PCN #: 2546

PCN Title: Transfer Assembly and Test Line to Diodes Subcontractor Eris Technology Corp. (ERIS) in Taiwan for Select Lite-On Semiconductor (LSC) Brand Automotive Products

PRODUCT CHANGE NOTICE**PCN-2546 REV1**

Table 2 – Part Marking Format

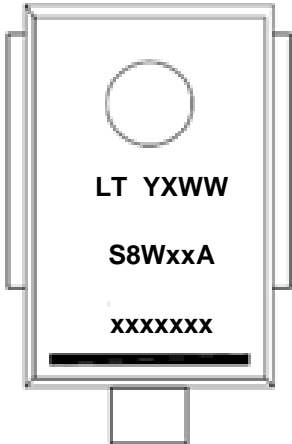
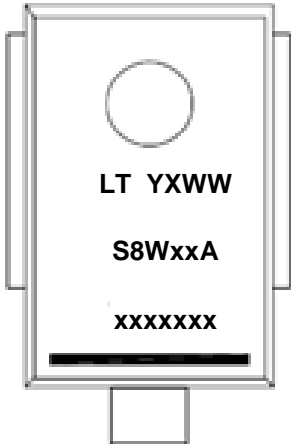
| Keelung Assembly and Test Site (Before) | ERIS Assembly and Test Site (After) |
|---|--|
| <p>Date code Y : For year X : Assembly site code, "J"= Keelung A/T. WW : Week code</p> <p>S8WxxA : Part number LT : Logo xxxxxx : Assembly tracking code</p> | <p>Date code Y : For year X : Assembly site code, "E"= ERIS A/T. WW : Week code</p> <p>S8WxxA : Part number LT : Logo xxxxxx : Assembly tracking code</p> |
